Side by side installation HCR cabinets – Handle change

DESCRIPTION:

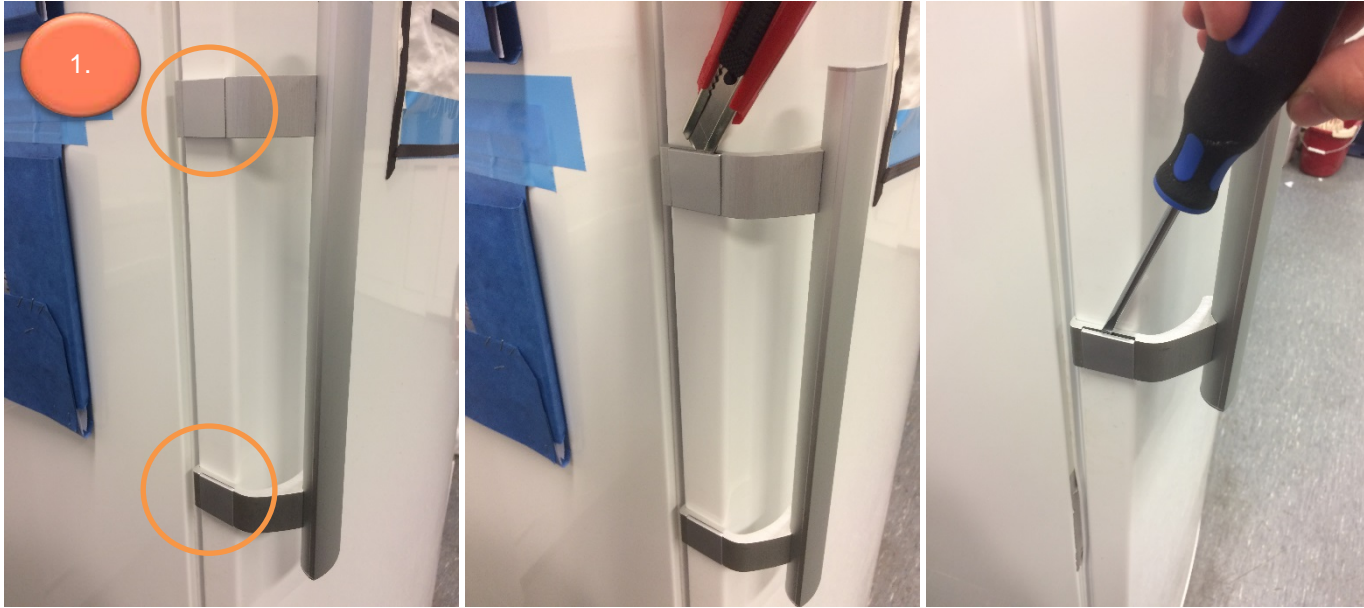
The handles need to be exchanged on freestanding freezer and refrigerators when installed side-by-side.

The cause of the problem is the thickness of the handles. To avoid customer claims, it is possible to exchange the handles for a thinner model.

This solution does not modify the appearance of the appliances.

1. Take off the plastic covers from the old handle.

2. Take out the screws and then the handle.

3. Install the new handle and fasten it with the screws.
